Kennecott Eagle Minerals Company's Mining and Reclamation Plan And Draft Comments From The DNR

**State of Michigan
Department of Natural Resources
Metallic Minerals Lease No M-00602**

Illustration 4-5
Groundwater Dewatering System

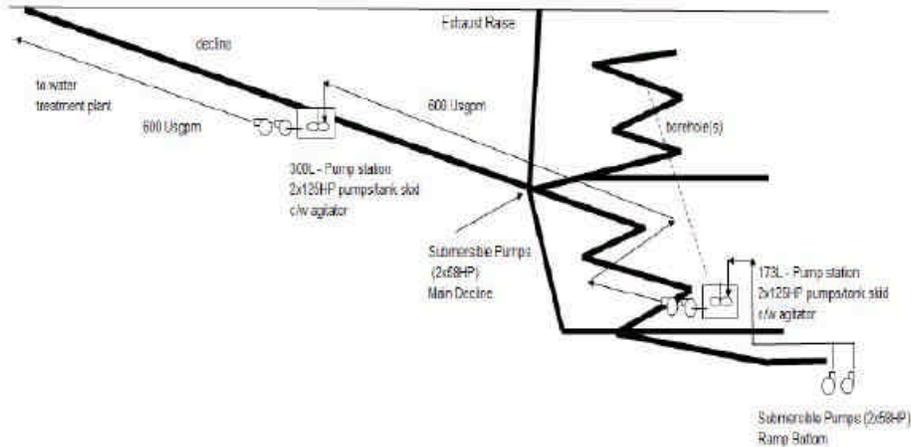
DNR Comments Kennecott shall notify the DNR within 10 days if ground water inflows exceed 300 gallons per minute. Kennecott shall develop plans to respond to ground water inflow if it exceeds 300 gallons per minute
